ADDENDUM 4

September 11, 2018

Contract 15-C-00044; Louisiana Pump Station Rehabilitation

SHEET
A-17

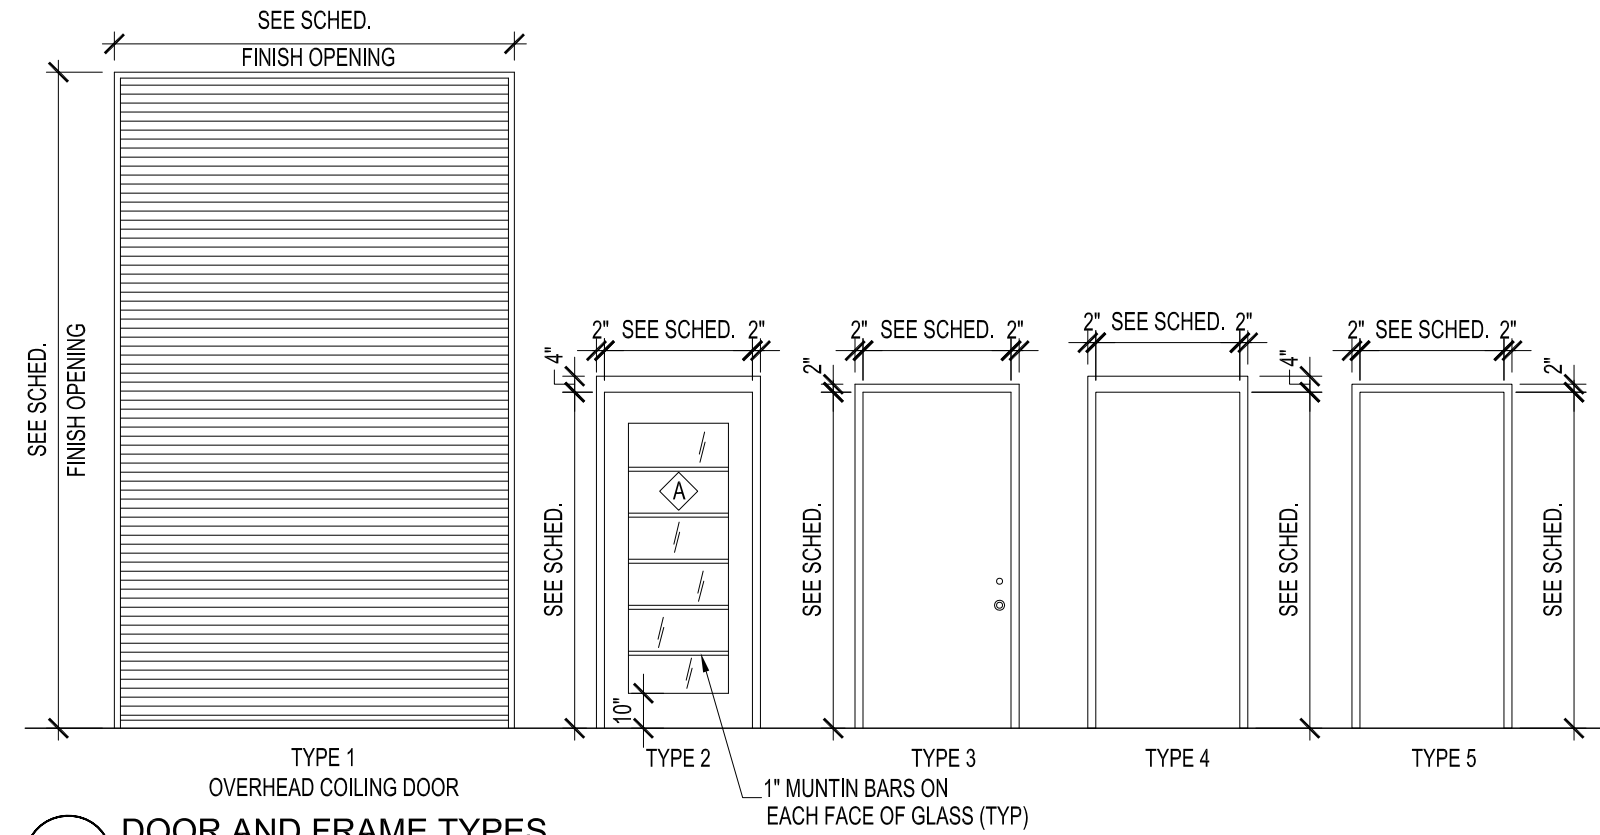
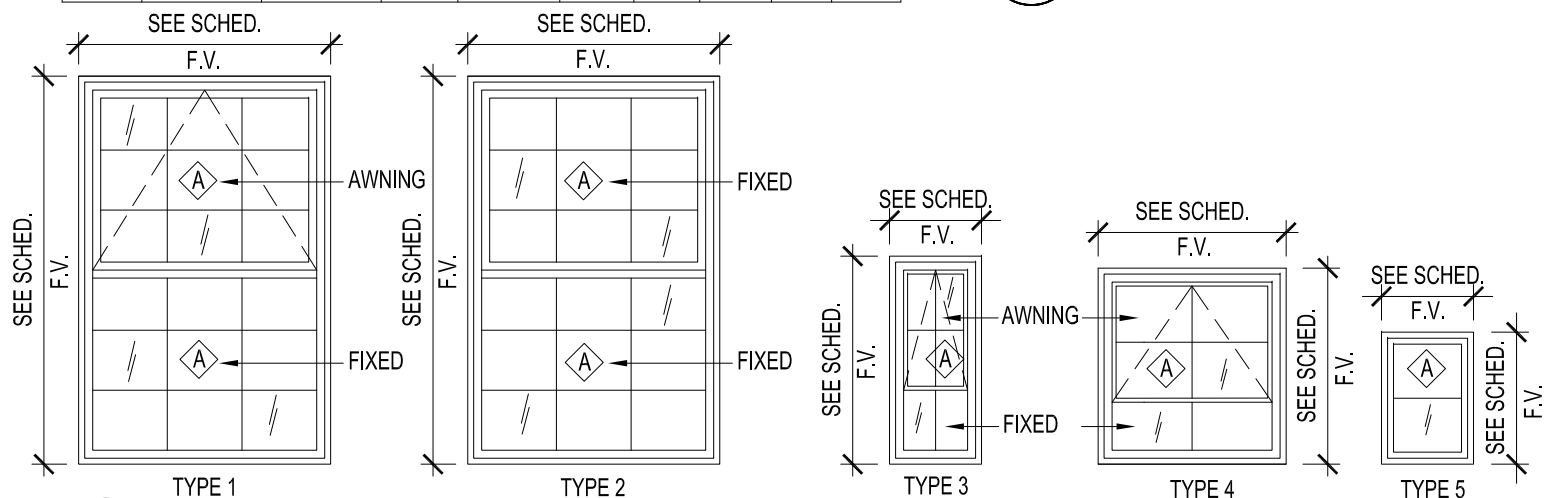
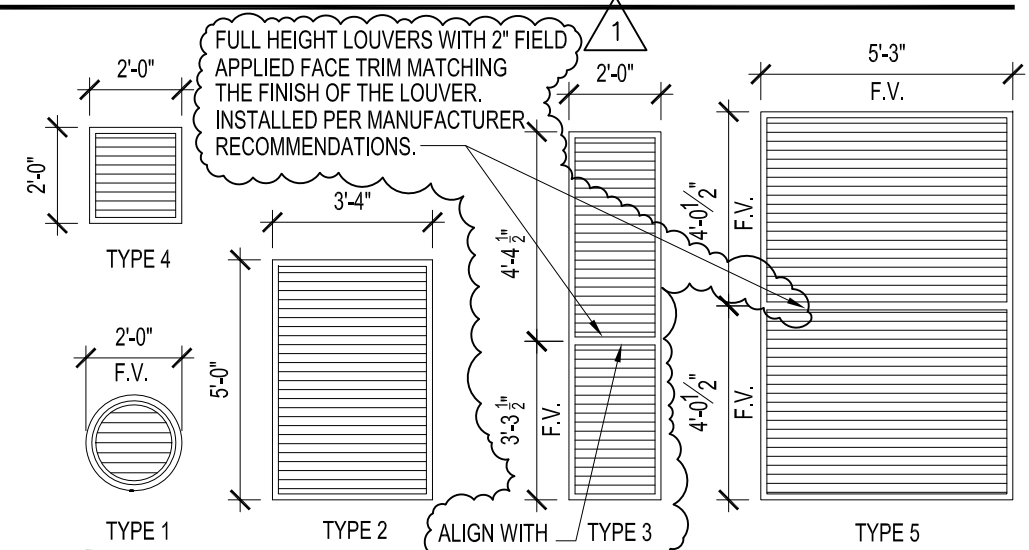
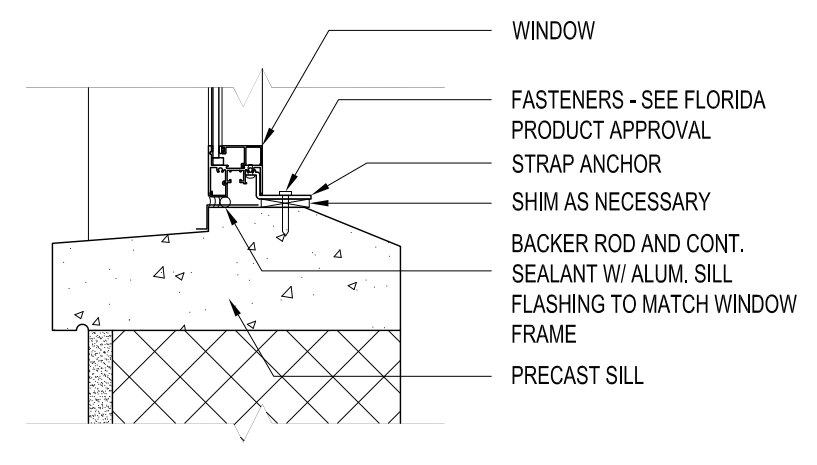
Item 4: Replace Architectural Sheets A-17 and A-18 with the attached revised sheets.
